ADDENDUM | No. 1

PROJECT	Campground Development Phase II, Civil Package - Rebid	
BID DATE	3:30 PM CST	January 26, 2023
BID LOCATION	Foss Building 523 East Capitol Avenue Pierre, SD 57501-3182	
ISSUE DATE	January 19, 2023	
NOTICE	Failure to acknowledge all addenda in the BID may cause rejection of the BID. See Instructions to Bidders.

CAMPGROUND DEVELOPMENT
PALISADES STATE PARK-PHASE II
MINNEHAHA COUNTY, SOUTH DAKOTA

PAGE
C-310
OF
C-334

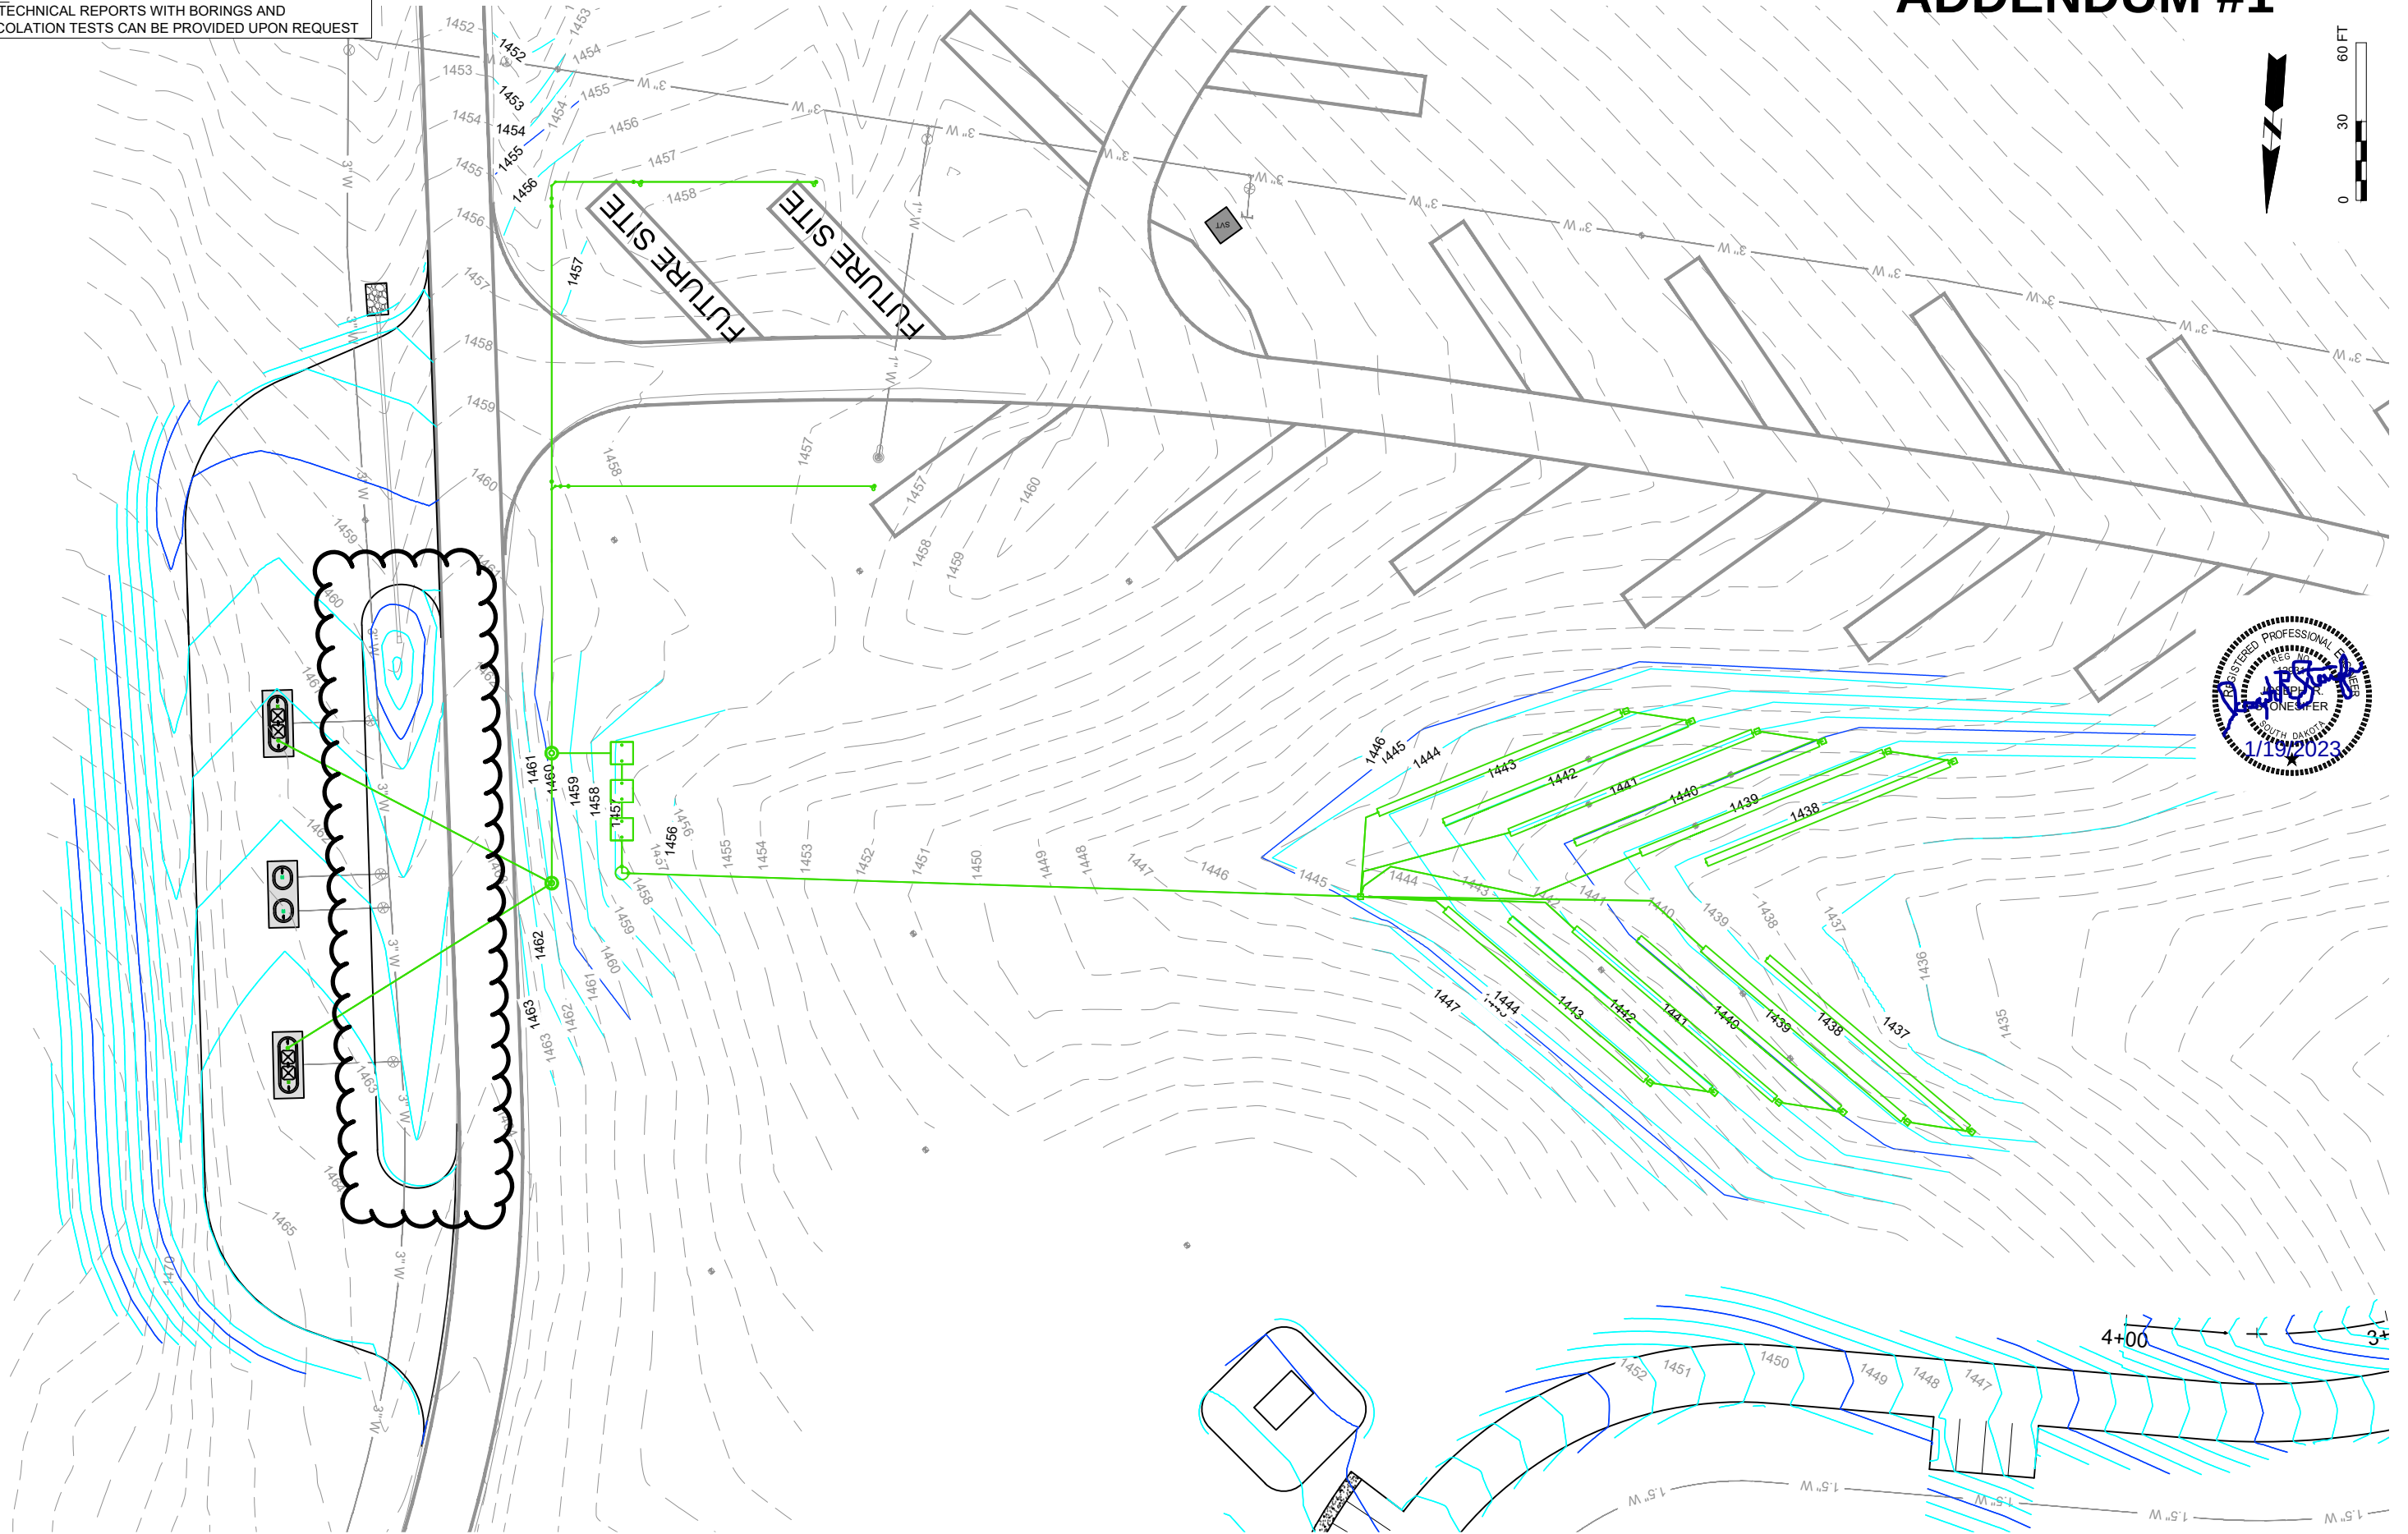
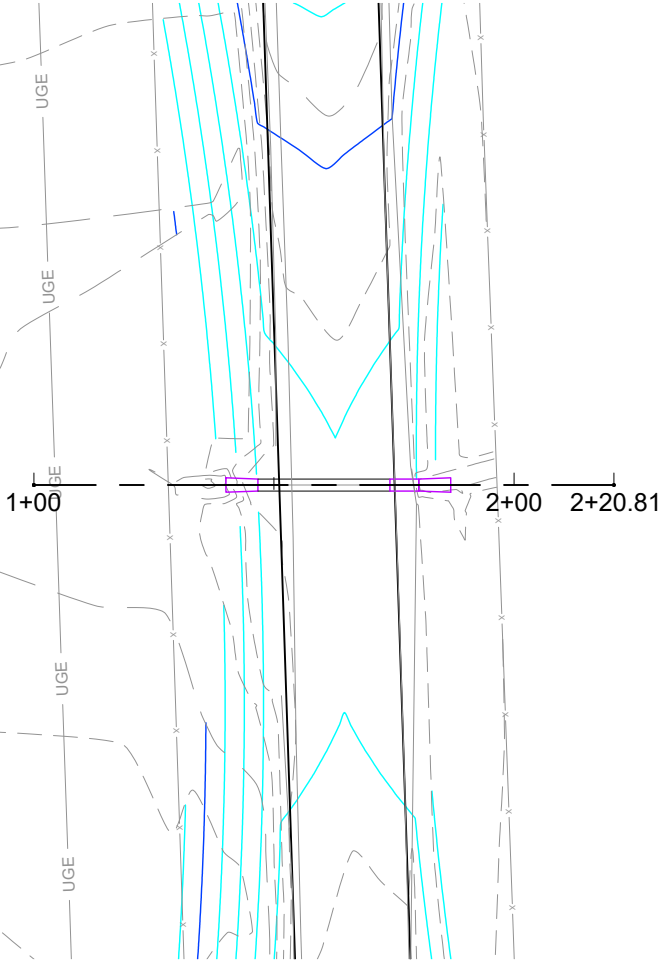
3) *Sheets C-310, C-322, C-414, and C-415 – Dump Station Median Site Grading*

Site grading contours in the dump station median have been added to the plan sheets.
